RE: PLUS review – PLUS 2006-12-08; Branchside

According to the information received, you are seeking site plan approval for 65 residential units on 37 acres.

**Map of Branchside (PLUS 2006-12-08)** Excellent ground-water recharge potential area is highlighted in green. The parcel under review is outlined in red.

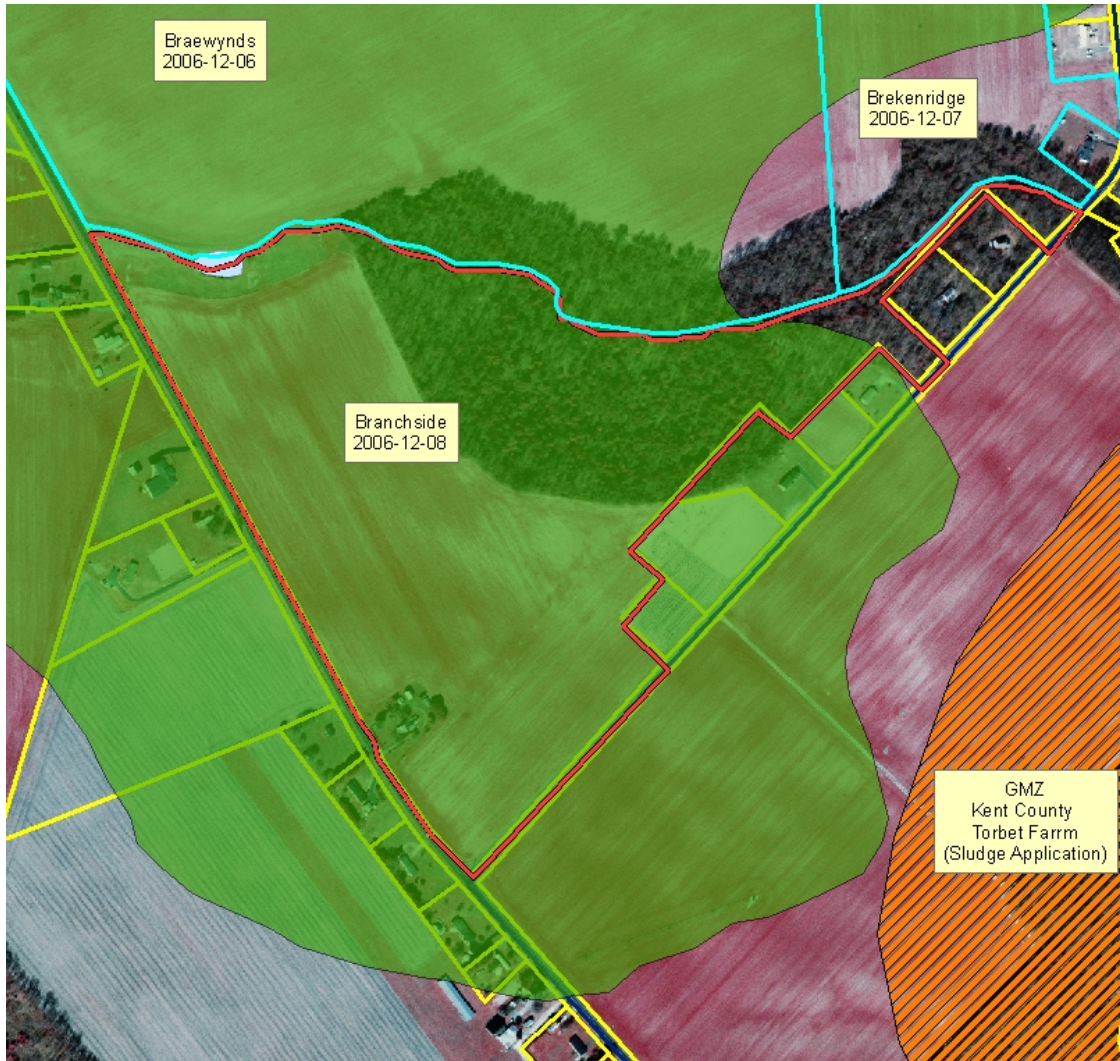
The Water Supply Section has determined that it falls entirely within an excellent ground-water recharge area for Kent County (see following map and attached map). The site plans show storm water management ponds in the area of excellent recharge.

The Water Supply Section recommends that the portion of the new development within the excellent ground-water recharge area not exceed 20% impervious cover (DNREC, 2005). The purpose of an impervious cover threshold is to minimize loss of recharge (and associated increases in storm water) and protect the quality and quantity of ground water and surface water supplies.
